BID No. 2020-021 - ADDENDUM #1

**SOLICITATION OF BIDS
THERMAL REMEDIATION OF VOLATILE ORGANIC COMPOUNDS
FORMER WASTEWATER TREATMENT FACILITY
SARL DRIVE
SALEM, NEW HAMPSHIRE**

Date: January 15, 2021

SEWER INTERCEPTOR AS-BUILT PLANS AND PORTIONS OF GZA SITE PLAN

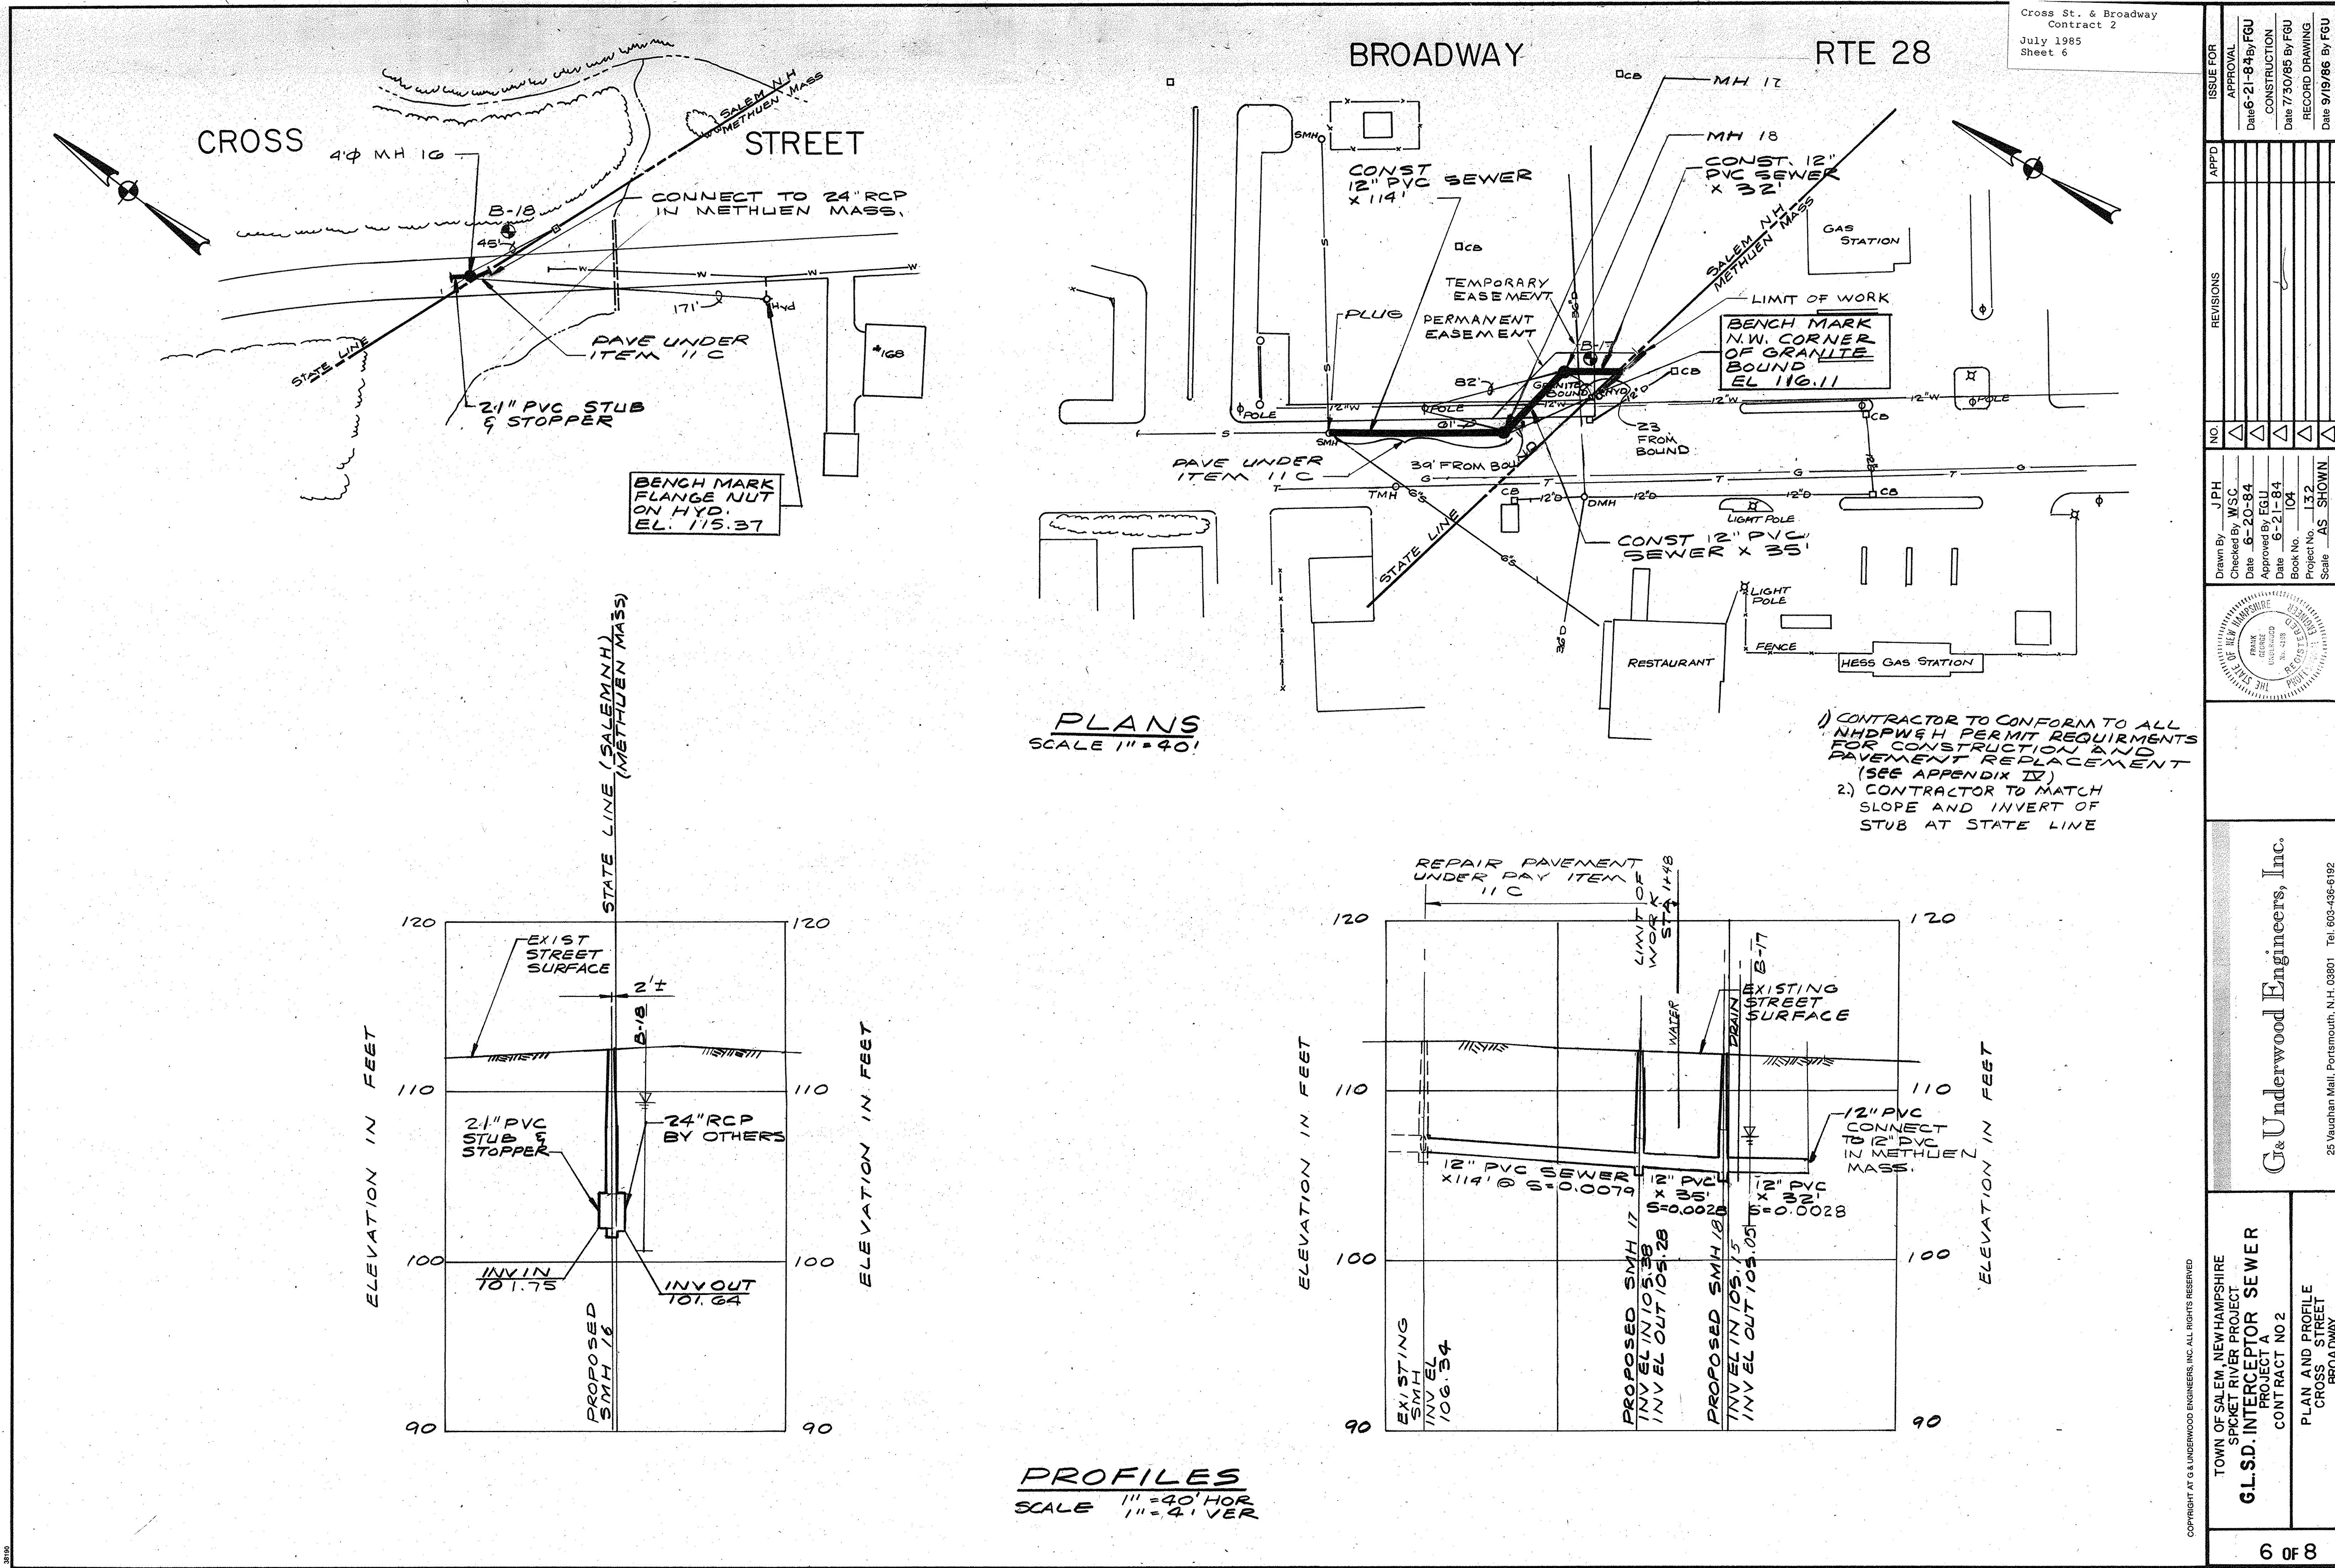
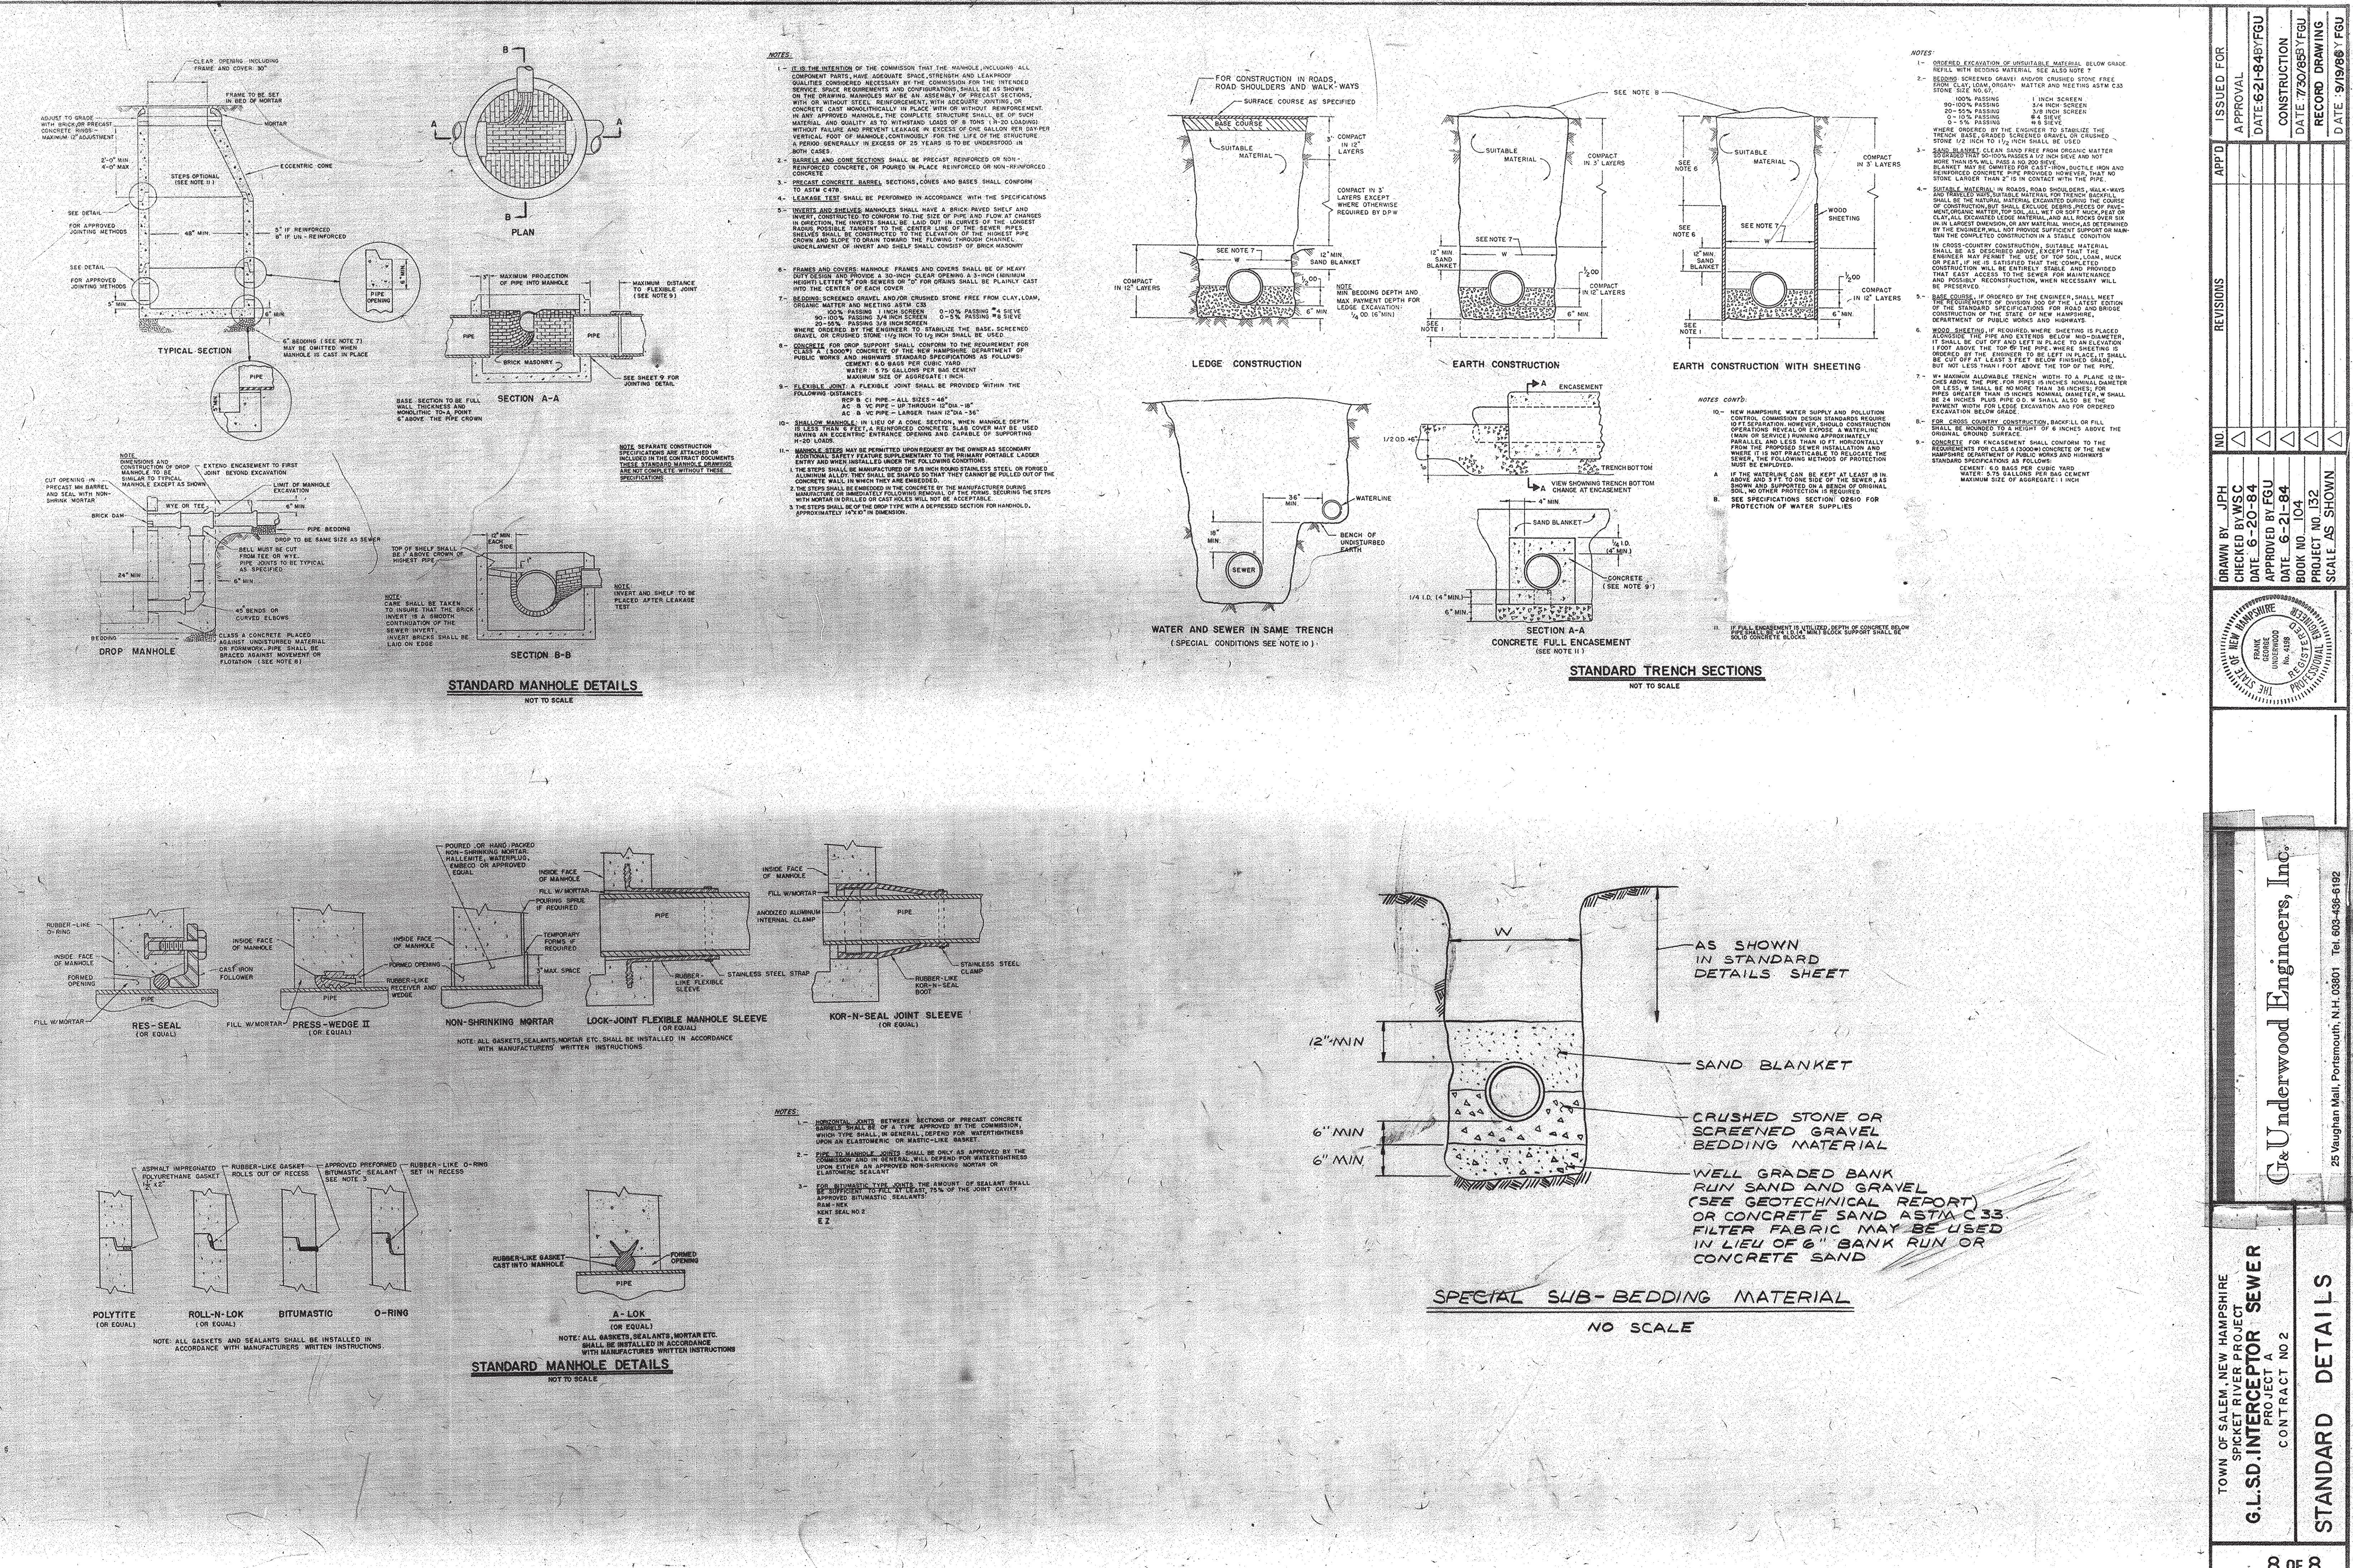
Question: What are the sewer line specifications such as materials, construction details, installation depths, etc?

Response: As-built plans for the 42-inch reinforced concrete pipe (RCP) as presented in Attachment B. Attachment B also include portions of a GZA site plan showing the 42" RCP sewer line.
